Access Compliance Report

Public Rights-of-Way

| Intersection ID: 5763 | Main Street: RICHFIELD_LN | Cross Street: STATESVILLE_RD | Location: NW |
| ADA ID: 195F871EA430 | Ramp Type: Directional1 | Initial Pass/Fail: Fail | Overall Compliance: No |

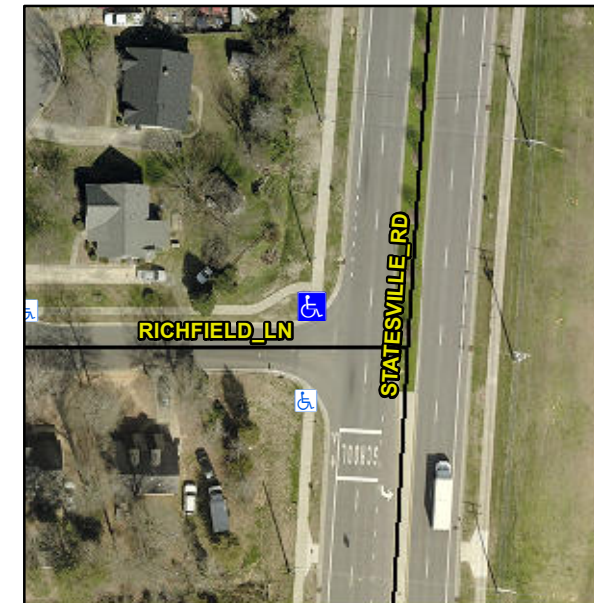
DAMAGED LT FL

R304.2.2

| Compliance | Description | Data | Compliance | Description | Data |
|------------|-----------------------|------|------------|-----------------------------|------|
| No | Ramp Slope (%) | 10.2 | N/A | Grade Break XSlope (%) | 0.0 |

Remove & Replace Entire Ramp.
